1. Barber Subdivision; KPB File 2023-013

KPB File 2023-013
T 05N R 10W SEC 8
Ridgeway

ITEM 1 - BARBER SUBDIVISION

KPB File No.	2023-013
Plat Committee Meeting:	February 27, 2023
Applicant / Owner:	Matt Barber of Hickman, Nebraska
Surveyor:	Jason Schollenberg / Peninsula Surveying, LLC
General Location:	Strawberry Road, Ridgeway

PLAT OF
BARBER SUBDIVISION

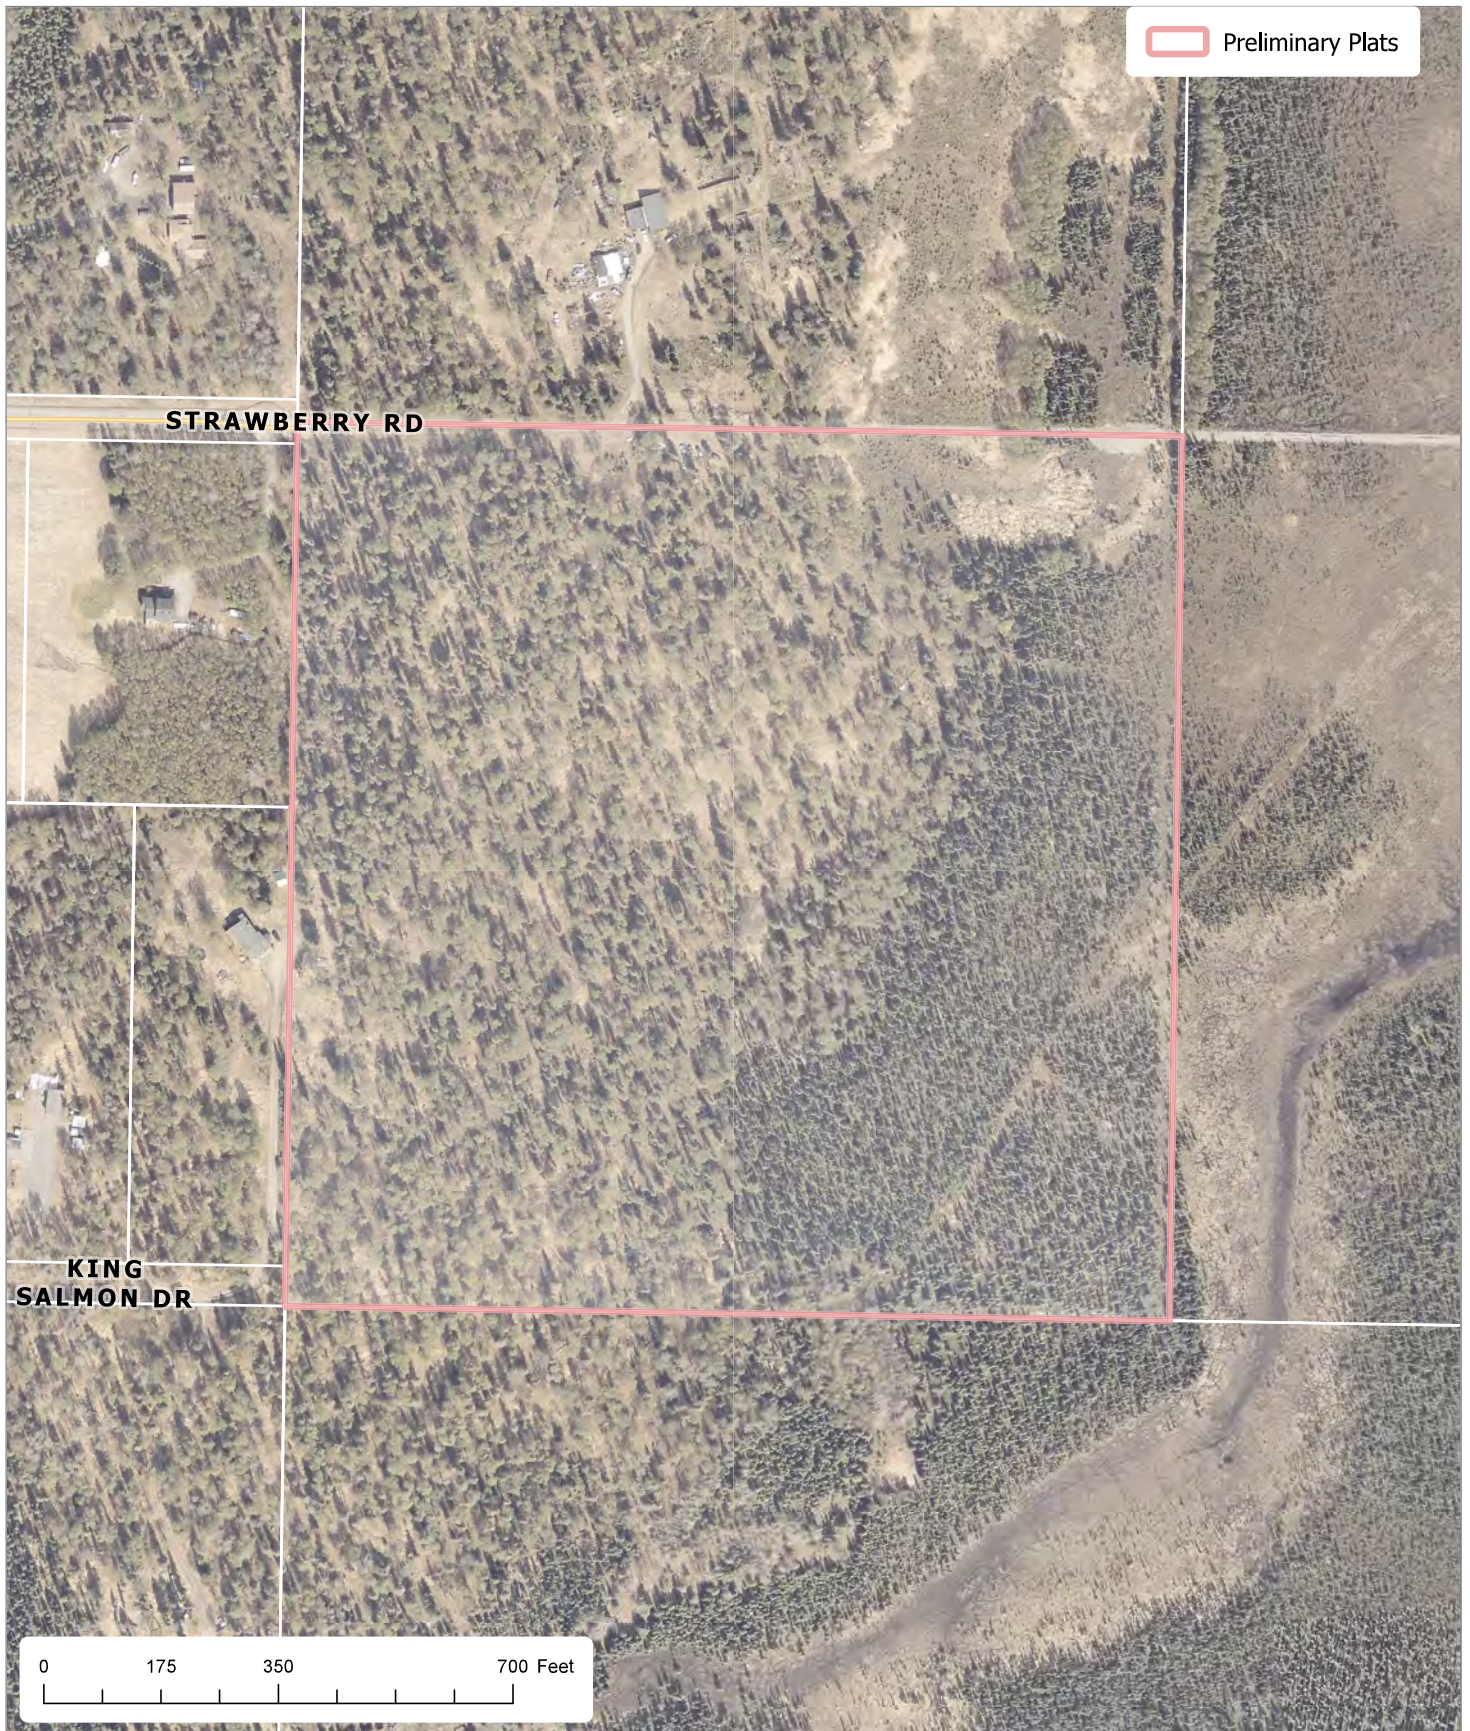
This plat is proposing to dedicate a 30 foot width for Strawberry Road atop an existing 33 foot section line easement. It appears to be cleared and used for access for the lot to the north as well as a large acreage lot to the east with improvements present. The northern portion of Strawberry Road appears to be subject to a 33 foot section line easement to provide additional width. If the owner to the north ever subdivides a matching dedication can be obtained. The western portion of Strawberry Road appears to contain some steep slopes. ***Staff recommends proof that the slopes comply with code or submittal of centerline profiles and cross-sections be submitted for review to determine if additional width or easements are required.***

Section line easements are along the northern boundary. **Staff recommends adjacent section line easements should be shown if right-of-way dedications have not been granted.**

Site Investigation: The property contains some low wet area within the eastern portion. **Staff recommends the wetlands remain on the final plat along with the determination note.**

Steep areas appear to be present within the proposed Strawberry Road dedication. The recommendation regarding the dedication is made within that portion of the staff report. The steep areas do appear to continue down into proposed Lots 1 through 4. **Staff recommends the slopes be verified and if any exceed 20 percent that the steep areas be depicted in some manner as it may impact development on lots of this size.**

A soils report will be required and an engineer will sign the final plat. Lot 10 does appear to contain low wet areas throughout and Lots 1 through 4 may have steep slopes. Any wastewater issues due to terrain should be shown on the soils analysis report. Lot 18, due to its size, does not require a soils analysis report.

An easement granted by recorded document was granted to Homer Electric Association, Inc. in 1959. Per the Certificate to Plat, the easement was released in 1997. It appears within the release that HEA reserved a 20 foot wide electrical distribution line easement centered on existing powerlines. **Staff recommends the surveyor work with HEA to determine the possible location of the reserved easement to depict, if the location cannot be found as the original easement had no defined location, then add plat notes with the original document information and the remaining easement.**

- Staff recommendation:** A new unique subdivision name will be required as there is a Barber Tract Subdivision, KN 83-272.
- C. The location, width, and name of existing or platted streets and public ways, railroad rights-of-way, and other important features such as section lines or political subdivisions or municipal corporation boundaries abutting the subdivision;
Staff recommendation: Provide section line easement designations to the east of the subdivision. The City of Kenai limits are located along the western boundary. Provide a depiction and label.

- D. A vicinity map, drawn to scale showing location of proposed subdivision, north arrow if different from plat orientation, township and range, section lines, roads, political boundaries, and prominent natural and manmade features, such as shorelines or streams;
Staff recommendation: Provide a Township label.

- L. Contours at suitable intervals when any roads are to be dedicated unless the planning director or commission finds evidence that road grades will not exceed 6 percent on arterial streets, and 10 percent on other streets;
Staff recommendation: The western portion of Strawberry Road dedication appears to have some slopes near 11 percent.

- M. Approximate locations of slopes over 20 percent in grade and if contours are shown, the areas of the contours that exceed 20 percent grade shall be clearly labeled as such;
Staff recommendation: *There appears to be some areas with slopes greater than 20 percent within lots within the northwest portion.*

Staff recommendation: *Provide documentation that the slopes comply with code or provide centerline profiles and cross-sections for Strawberry Road for review to determine if additional right-of-way width or easements are required.*

Staff recommendation: *Add the plat note: No structures are permitted within the panhandle portion of the flag lots.*

Platting Staff Comments: Soils report will be required for Lots 1-17. Lot 18 does not require a soils report.
